ZONING COMMITTEE STAFF REPORT

FILE NAME: McDonald's

FILE # 18-106-569

TYPE OF APPLICATION: Conditional Use Permit

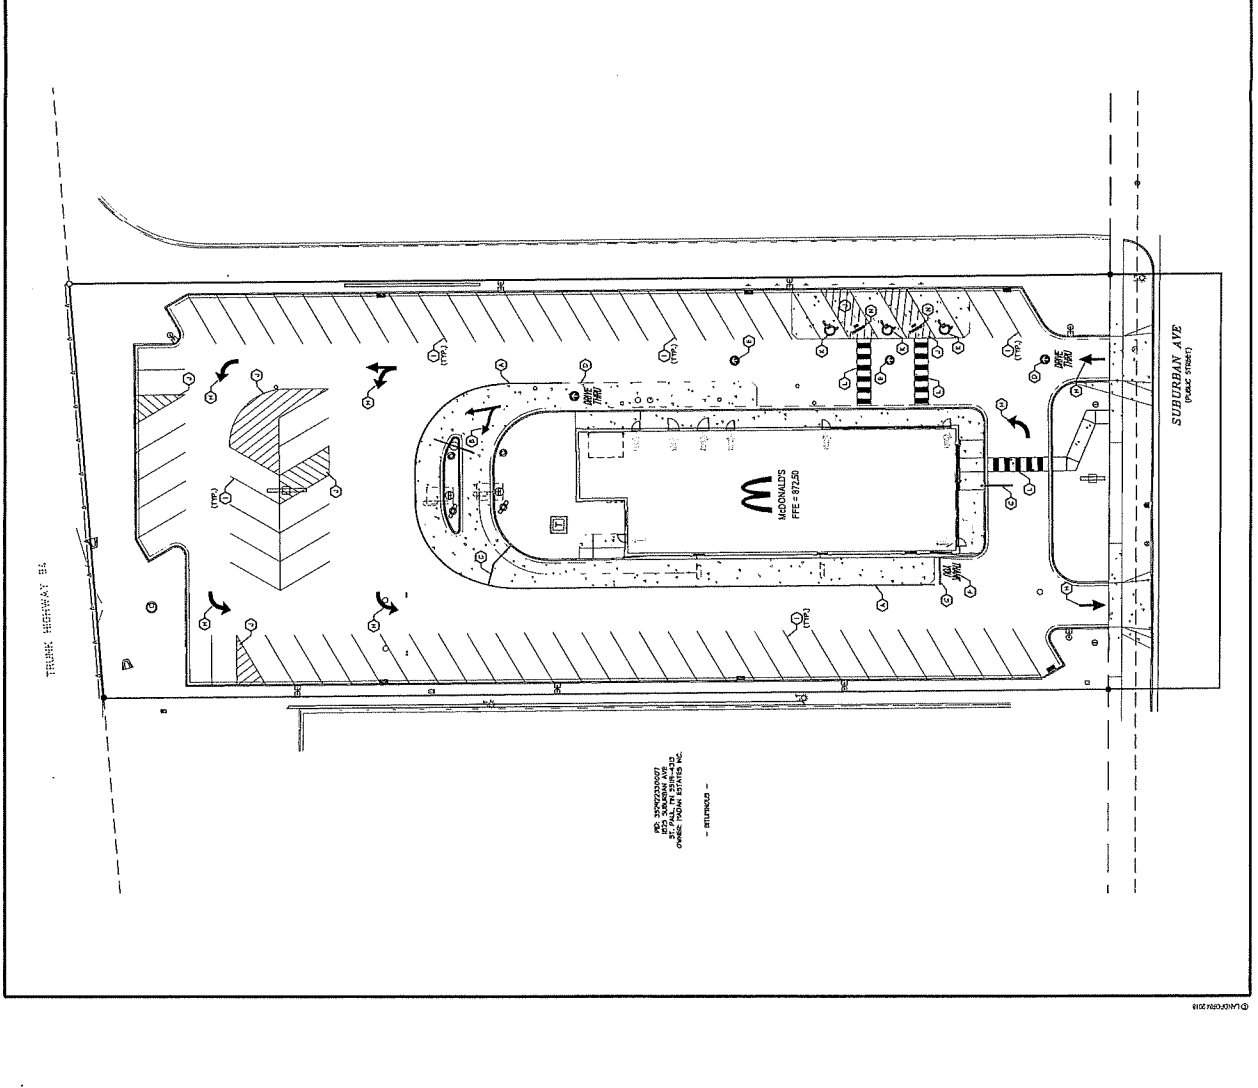
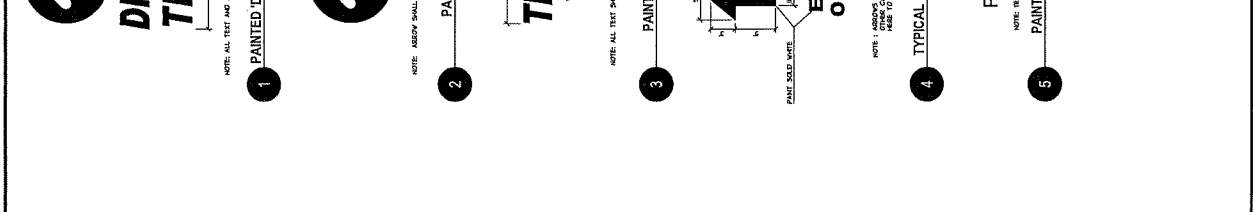
- F. **PARKING:** Zoning Code §63.207 requires a minimum of 15 parking spaces for the proposed 6,013 square foot building. The application materials incorrectly present the minimum as 16 spaces, perhaps due to a failure to round down as directed by §63.206. §63.207(c) establishes a maximum of 200% more than the minimum, which calculates to 45 parking spaces for this use.

3. §63.207(c) states that parking facilities exceeding the minimum parking requirement by more than 200% for this type of use “*shall not be created unless a conditional use permit is approved based on demonstration of need.*” This finding is not met. The proposed building requires a minimum of 15 parking spaces, which calculates to a maximum parking requirement of 45 spaces, compared to a proposed provision of 75 spaces. The application provides data from July 2018 showing that up to 38 parking spaces were used during peak hours. The application goes on to state that up to 30 employees are on-site at peak times, and that 6 to 7 spaces are needed for mobile orders. However, the employees’ parking need is already incorporated into the 38 vehicles observed in July. The parking maximum of 45 spaces would accommodate 38 vehicles, the amount of need that has been demonstrated, plus up to 7 spaces for mobile orders or additional demand.

- (f) *There shall be no more than one (1) drive-through lane and no more than two (2) drive-through service windows, with the exception of banks, which may have no more than three (3) drive-through lanes.*
This finding is partly met. Though the drive-through lane splits to two menu boards, it is generally a single drive-through lane. Three (3) drive-through service windows are proposed, which is the subject of a requested modification addressed below.

7. The planning commission may approve modifications of special conditions when specific criteria of §61.502 are met: *strict application of such special conditions would unreasonably limit or prevent otherwise lawful use of a piece of property or an existing structure and would result in exceptional undue hardship to the owner of such property or structure; provided, that such modification will not impair the intent and purpose of such special condition and is consistent with health, morals and general welfare of the community and is consistent with reasonable enjoyment of adjacent property.* This finding is met with regard to the modification requested to §65.513(f) in order to permit three (3) drive-through windows instead of the maximum of two (2). The third drive-through window is a pull-forward window for items that take longer to prepare, which allows efficient use of the restaurant. The third window does not impair the intent of the condition, which is to prevent drive-throughs from becoming overly dominant over the streetscape, because it does not extend the drive-through in this wrap-around-the-building layout.

8. §61.601 establishes required findings for the planning commission to grant variances:
- (a) *The variance is in harmony with the general purposes and intent of the zoning code.* This finding is met for the variance for floor area ratio (FAR) under 0.3 (0.108 proposed), but not met for the other variances. The variances to allow a front yard setback greater than 10 feet (54.5' proposed) and parking in the front yard do not implement the policies of

This finding is met for the variance for floor area ratio (FAR) under 0.3 (0.108 proposed), but not met for the variances to allow a front yard setback greater than 10 feet (54.5' proposed), parking in the front yard, and lack of height (2 stories or impression thereof required). The *2030 Comprehensive Plan* in Figure LU-B designates the site as part of a Mixed Use Corridor and Neighborhood Center. The *District 1 Plan* contains several policies relevant to the application, including: Policy LU-5.1 "Uphold design standards as required by City Code"; and Policy LU-5.5, which "(e)ncourage(s) changes to the design of existing auto-oriented commercial buildings and areas with elements of traditional urban form to improve the pedestrian realm." The *Gold Line Station Area Plans* call for zoning and design standards that support high-intensity transit-oriented development. The front yard setback greater than 10 feet and provision of parking in the front yard are contrary to these cited plan elements. The impact of the FAR variance, however, would be mitigated by making the building appear taller than one story, as is required by the T2 design standards. Also, placing the building closer to the street would mitigate the impact of lesser FAR by preserving more of the site for future development.

1. Zoning Administrator approval of a site plan with a single curb cut on Suburban Avenue rather than the proposed two curb cuts.
2. Trash receptacles shall be housed in a three-sided masonry enclosure, six feet high, or equal in height to the dumpster, whichever is greater and have an entrance gate constructed of a durable, opaque material.
3. Excessive lighting shall be avoided.
